March 17, 2014

**RE: Application for Coastal Development Permit  
ZA 2012 130, ENV 2012 131 MND,  
Project @ 16990-17000 Sunset Blvd., Pacific Palisades, CA 90272**

# EASEMENT EXHIBIT

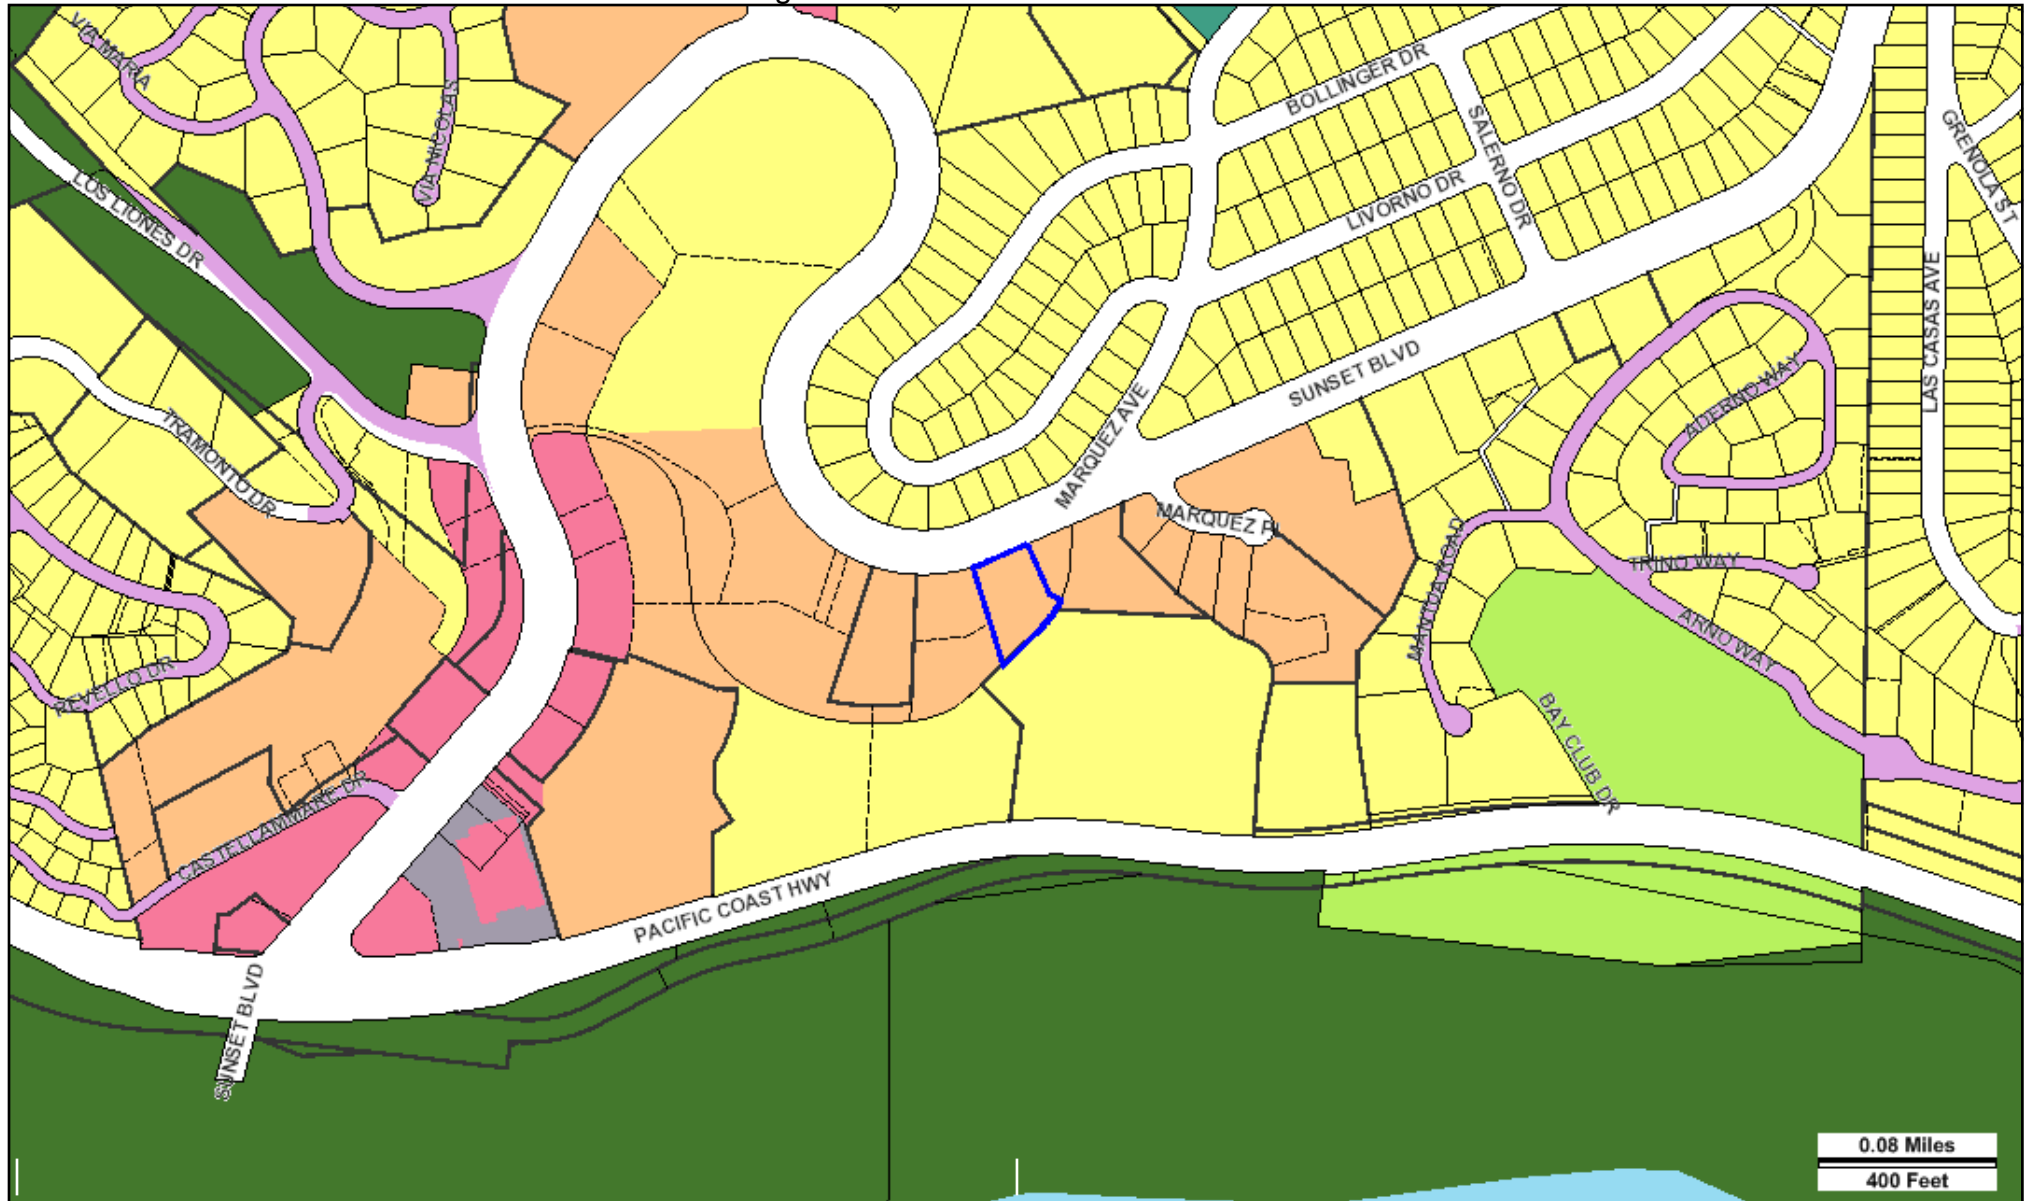
Second, Mr. Gaines's letter asserts that the subject easements do not run directly through Malibu Village. This is demonstrably false. As shown in the aerial view Easement Exhibit to the August 19, 2013 Building Revisions, the sewer and utility easements along the western property line of Malibu Village run directly under an occupied home in the southerly row of homes.

SECTION C-C  
SCALE: 1" = 40'

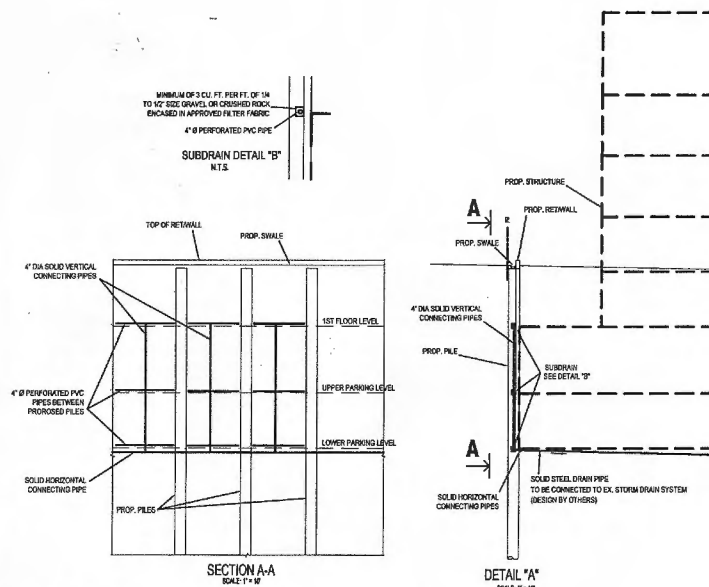
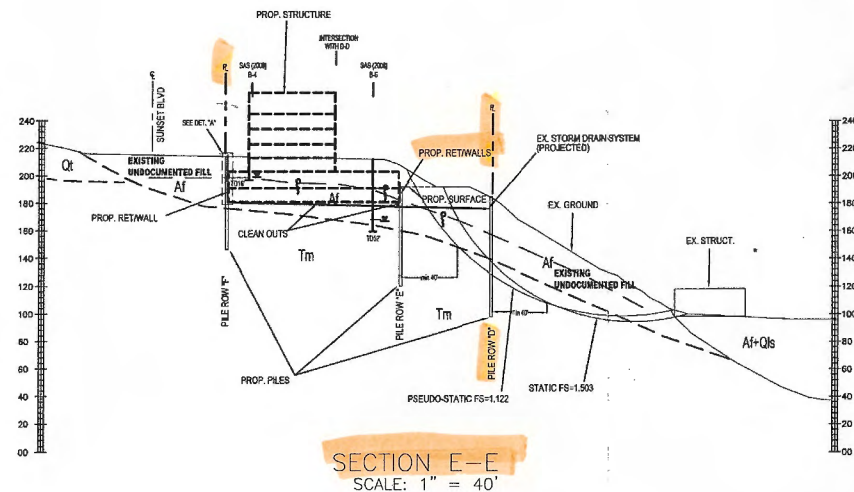
Q17 - *It is unclear from the scale of the cross-sections and scope of the project whether foundations will be located on or near a descending slope. Provide minimum setback from the bedrock slope where the recommended passive bearing may be assume supported be analyses as appropriate that consider shear strength parameters of bedrock, gradient and height of descending slopes.*

A17 - The cross-sections have been modified to show the Code required minimum setbacks from the bedrock surface or a plane with a factor of safety of 1.5.
